DAVIS-BESSE, UNIT 1

TABLE 3.6-2 CONTAINMENT ISOLATION VALVES

The purpose of this significant hazards consideration is to review proposed changes to Davis-Besse Nuclear Power Station (DBNPS), Unit Number 1 Operating License, Appendix A, Technical Specifications (TS) 3/4.6.3.1, Containment Isolation Valves, Table 3.6-2, Containment Isolation Valves, TS 3/4.6.1.1, Containment Integrity, TS Definition 1.8, Containment Integrity, and TS Bases 3/4.6.3, Containment Isolation Valves. This request proposes to remove TS Table 3.6-2 from the TS and relocate the list of containment isolation valves and associated information to the Updated Safety Analysis Report (USAR). This change would allow changes to be made to the table in accordance with 19CFR50.59 while maintaining the surveillance test requirements for containment isolation valves in the TS. In addition, several administrative changes have been made for clarification purposes. The Technical Description (Attachment 1) discusses these changes.

TABLE 3.6-2

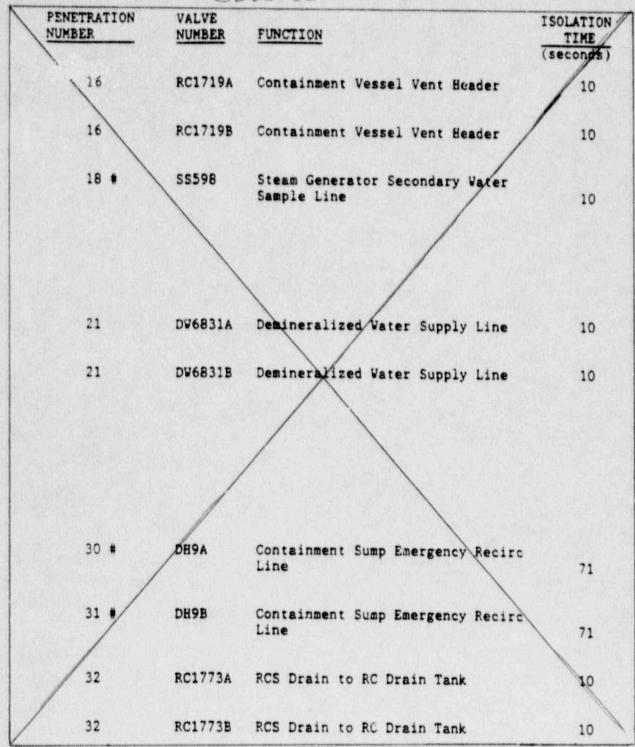
DELETED
